## PEER REVIEW STATEMENT – FOUNTAIN HEAD GROUNDWATER MODEL

ATTENTION:	David Browne, Principal, ERIAS Group	
FROM:	Hugh Middlemis, Principal Groundwater Engineer, HydroGeoLogic (HGL)	
REFERENCES:	7 July 2022	Fountain Head Gold Project (NT)
SUBJECT:	Fountain Head Groundwater Model Update for Supplementary EIS Response - Peer Review

Figure 1 - Fountain Head conceptual model for (after Li, 2022, Fig. 2-7)

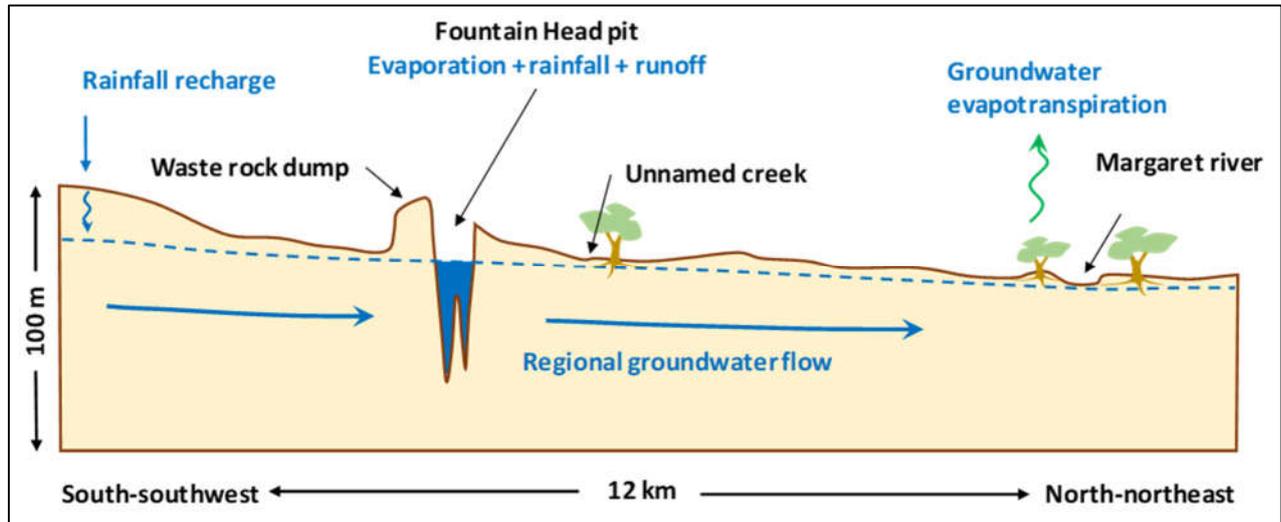
A key element of any groundwater model is the conceptual hydrogeological model that describes the geological framework, aquifer structure and the key flow system processes of natural and managed recharge, discharge and surface-groundwater interactions (GDEs) and related water quality characteristics, as illustrated in Figure 1 (after Li, 2022). In this case, the conceptual hydrogeological model is mature, based on extensive field and modelling investigations over a number of years.
